## **MICHAEL AND DIANE HALL FAMILY SUBDIVISION**

APPLICATION NUMBER 7 DATE March 20, 2008

APPLICANT Michael & Diane Hall Family Division Subdivision

REQUEST Subdivision

# DETAIL SITE PLAN

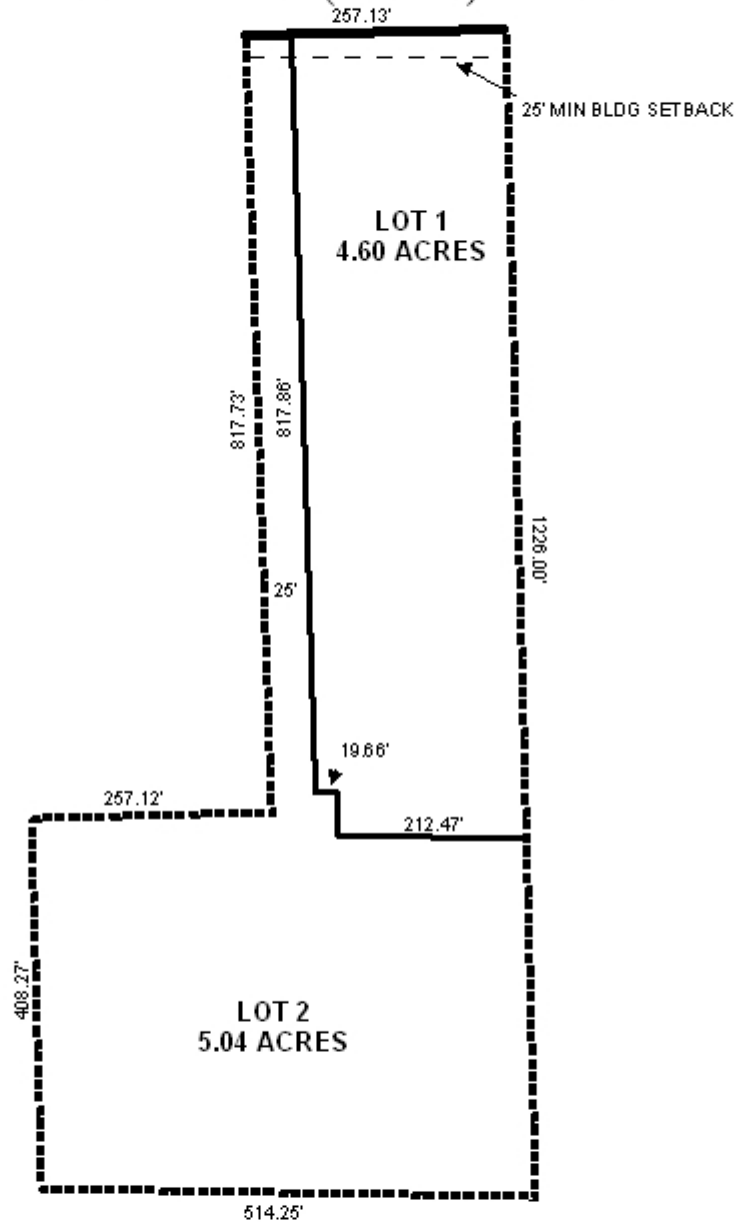
Proposed lots 1 and 2 have approximately 232' and 25' of frontage, respectively, along Calvert Road. As a means of access management, a note should be place on the final plat, if approved, stating that Lots 1 and 2 are limited to one curb each to Calvert Road, with the size, location, and design to be approved by County Engineering.

Proposed Lot 2 will be a flag lot with only 25' of frontage which will require a waiver of Sections V.D.1. and V.D.3. of the Subdivision Regulations. There is a flag lot (established prior to the expansion of the Planning Jurisdiction) across the street from proposed Lots 1 and 2 making it common to the area. Proposed Lot 1 will also require a waiver of Section V.D.1. This again, falls in line with the characteristic of the neighborhood. If approved, however, there should be no resubdivision of proposed Lot 2 until additional street frontage can be provided, and until Calvert Road is paved to Mobile County standards. Lot 1 should also be restricted from additional subdividing until Calvert Road is paved to Mobile County Engineering standards.

If approved, the minimum building setback line as depicted on Lot 2 should be moved back to be at least 25' from where the "pole" intersects the "flag" portion of the lot.

The lot sizes in square feet and acreage are indicated on the plat. The lot sizes in square feet, at a minimum, should also be depicted on the final plat, or a table provided furnishing the same information, if approved.

- 1) placement of a note on the final plat stating that Lots 1 and 2 are limited to 1 curb cut each, with the size, location and design to be approved by County Engineering;

- 2) revision of the plat to depict the minimum building setback line on lot 2 to be at least 25' back from where the "pole" meets the "flag" part of the lot;

- 4) labeling of each lot with its size in square feet;
- 5) while the site is in Mobile County, it will have to comply with the City of Mobile storm water and flood control ordinances. A note should be placed on the final plat stating that the development will be designed to comply with the storm water detention and drainage facility requirements of the City of Mobile storm water and flood control ordinances, and requiring submission of certification from a licensed engineer certifying that the design complies with the storm water detention and drainage facility requirements of the City of Mobile storm water and flood control ordinances prior to the issuance of any permits. Certification is to be submitted to the Planning Section of Urban Development and County Engineering;
